Errata Sheet

30 August 2001 / Release 1.4

Device:	C515C-L, C515C-8R
Stepping Code / Marking:	AA
Package:	P-MQFP-80

CAN.4: Flowchart sequence in figure in User's Manual regarding Micro-controller handling of the Last Message Object is partly incorrect

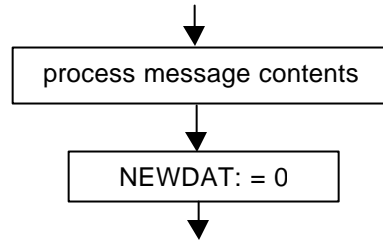
For the software flowchart figure 6-48 in User's Manual 11.97, the correct would be to first 'process message contents' and then to 'clear bit NEWDAT'.

This correction will be updated to the future versions of the User's Manuals.
